Accessory Service Bulletin

2012-14 Tacoma Parasitic Draw SET Accessory Fog Lights

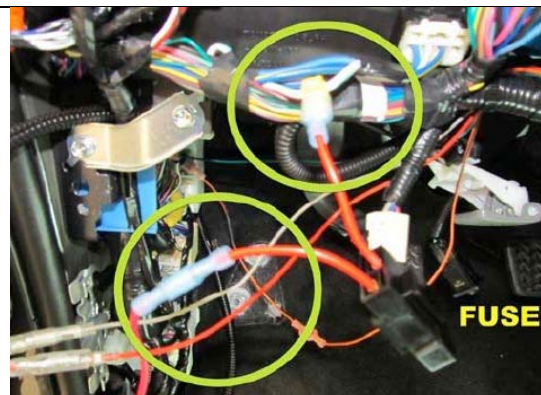
- The Fog Light Positive (Red) wire is connected to the Positive Battery Terminal.

- In this configuration the Accessory Fog light relays tied to the harness behind the driver’s kick panel will have 12 volts available at all times.
- Proceed to Repair Section in this TSB.

1. Replace Accessory Wire Harness

Reference 00016-35220 SET Accessory Installation instructions on TIS for replacement of 00016-35220-01 Wire harness.
